DAIFUKU JSP16-23

Consideration at the request of Northern Equities for approval of Preliminary Site Plan, and Stormwater Management Plan approval. The subject property is 7.36 acres located in Section 1 of the City of Novi and located north of Thirteen Mile Road and east of Cabot Drive. The applicant is proposing to construct a 2-story office building, consisting of 76,547 square foot office space and associated site improvements for office and research use for Daifuku North America Holding Company's headquarters.

PLANNING REVIEW

Review Date: June 30, 2016
Review Type: Preliminary/Final Site Plan
Project Name: **DAIFUKU**
Plan Date: June 13, 2016
Prepared by: Sri Komaragiri, Planner
E-mail: skomaragiri@cityofnovi.org; **Phone:** (248) 735-5607

ORIGINAL ISSUE DATE: JUNE 13, 2016
PEA JOB NO. 2016-088
SCALE: 1" = 40'
DRAWING NUMBER: C-4.0

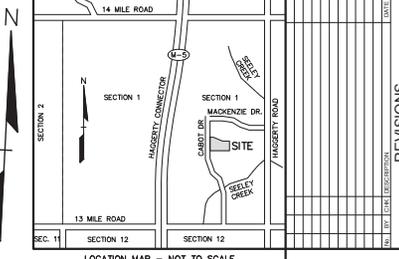
WALKER REQUEST:
ALONG THE NORTH PROPERTY LINE THE PARKING SPACE SETBACK (TO VEHICLE OVERHANG) IS 1 FOOT, NOT THE REQUIRED 20 FEET. THE DISTANCE BETWEEN THE NORTH PROPERTY LINE IS MADE UP FOR IN OTHER GREENBELT AREAS ON THE PROPERTY. REFER TO THE LANDSCAPE PLAN FOR DETAILED CALCULATIONS.

THE GREENBELT AREA THAT IS NOT PROVIDED ON SITE WITHIN THE PARKING SETBACK ALONG THE NORTH PROPERTY LINE IS MADE UP FOR IN OTHER GREENBELT AREAS ON THE PROPERTY. REFER TO THE LANDSCAPE PLAN FOR DETAILED CALCULATIONS.

3. A landscape waiver for the required right-of-way trees will be requested. The waivers will be noted on sheets C-4.0 and L-1.0 of the plans submitted for final stamping set approval.
4. A berm will be added to that area to the maximum extent possible without encroaching into the detention basin side-slopes.

DRAWING NUMBER:
 L-1.0

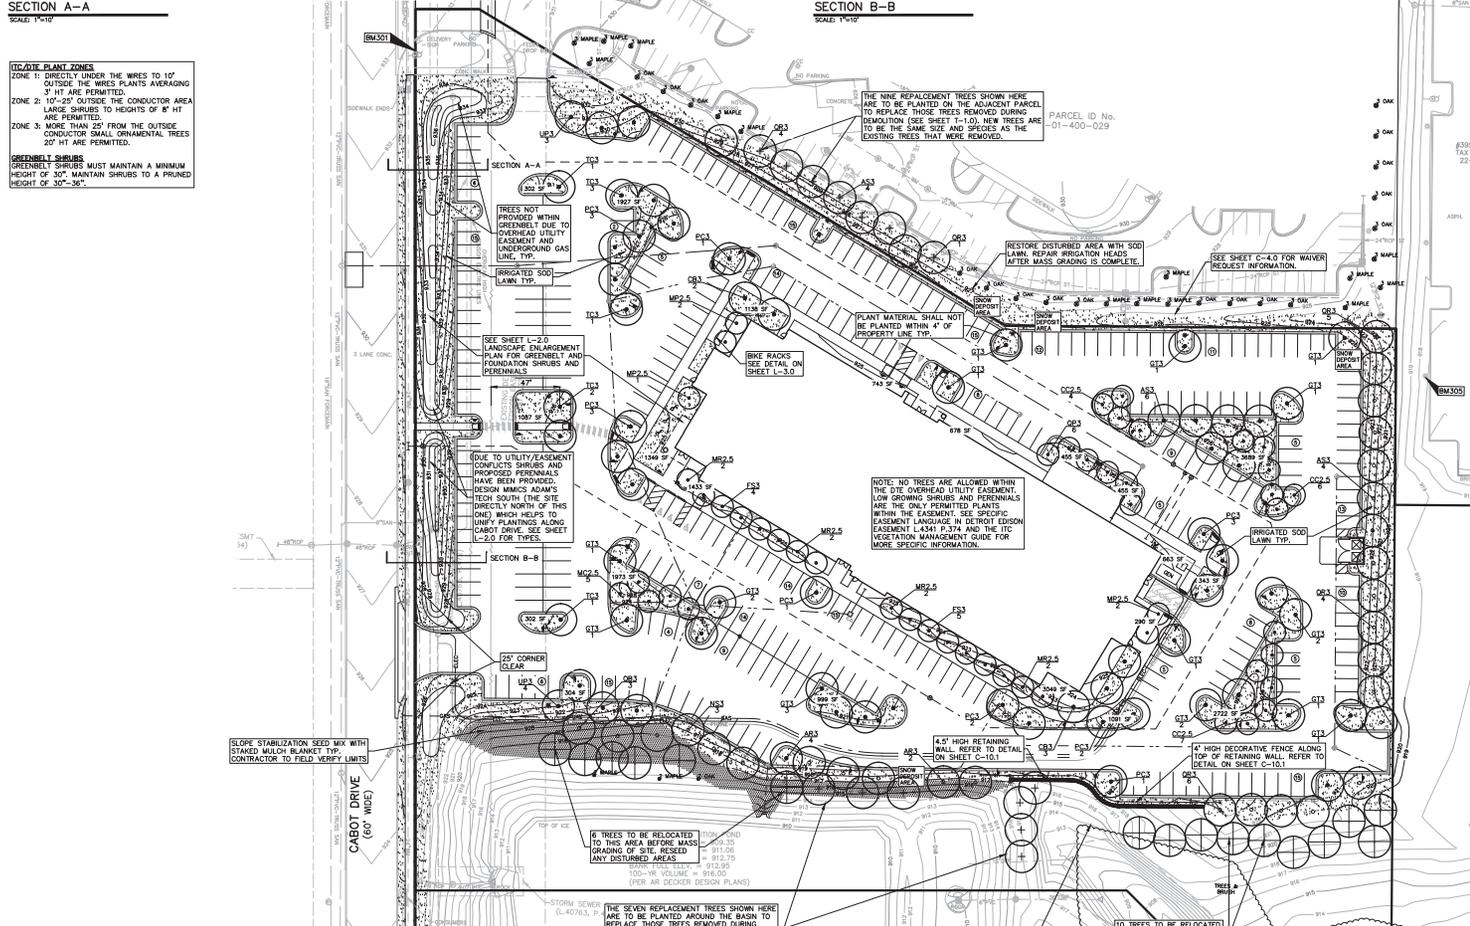
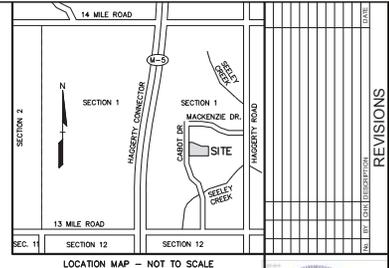
3. **It would be preferable, however, to trade out some of the subcanopy trees in the islands for larger canopy trees to provide more broadly spread shade for trees near the islands. This will decrease the total number of trees, but would be closer to the spirit and intent of the ordinance. Some of the subcanopy trees can be kept as accents and it is assumed that the islands will still be fully landscaped as they are now.**

4. **Please add shrubs or other landscaping on the islands, or portions of islands, where trees can't be planted due to the easement.**
5. **Please eliminate or sharply reduce the number of Flowering Pears (*Pyrus calleryana*) proposed. Although it is not yet on the state's Invasive Species list, it is behaving very invasively in southern Michigan, including in and around Novi, and we would like to reduce its use.**

1. The plant lists are provided and are satisfactory.
2. **Please change the cost of the seed to \$3.00/square yard.**

1. Planting details are provided.
2. **Please change all notes on Sheet L-4.2 to reflect a 2 year warranty period, not 1 year.**

- Dimensions will be included on sheets C-4.1 thru C-4.3 as needed.
- All trees will be shown at a minimum of 10' away from each hydrant.
- We will reduce the number of sub-canopy trees within the islands and provide more large deciduous trees. Since the quantity will not be met we will provide additional shrubs in islands that can't accommodate trees due to the ITC easement.
